AUTO RADIO SERVICE BULLETIN.

SUBJECT: FITTING 6 VOLT DISTRIBUTOR SUPPRESSORS.

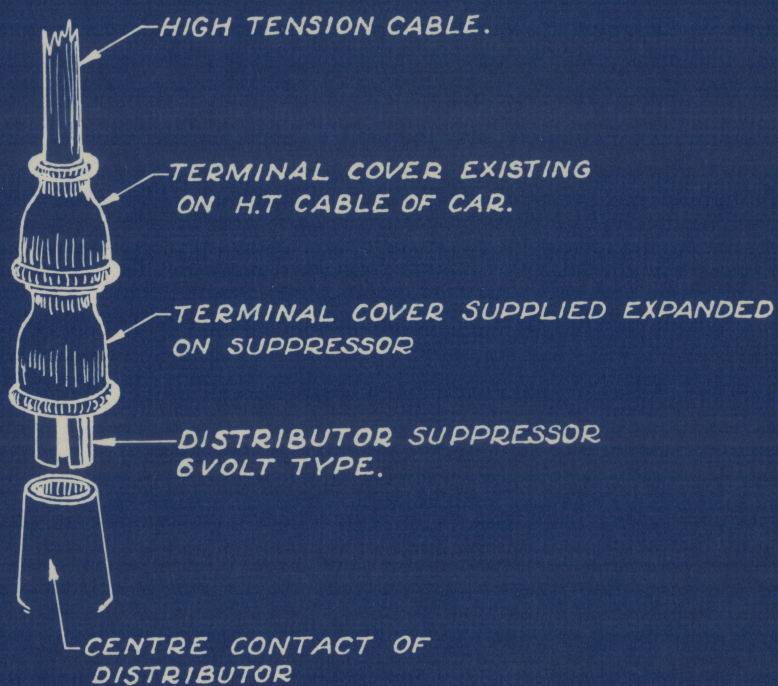
Trouble has been experienced with General Motors and other cars, with starting after radio has been fitted which was alleged to be caused by moisture getting into center connection of Distributor and suppressor fitted to same.

To overcome this the factory are in future fitting a Rubber terminal cover to each 6 volt suppressor so that the cover makes a shield to distributor when suppressor is plugged into distributor.

The existing terminal cover on the distributor is then used to shield the suppressor by threading on high tension cable and brought down over suppressor when connection is completed to same.
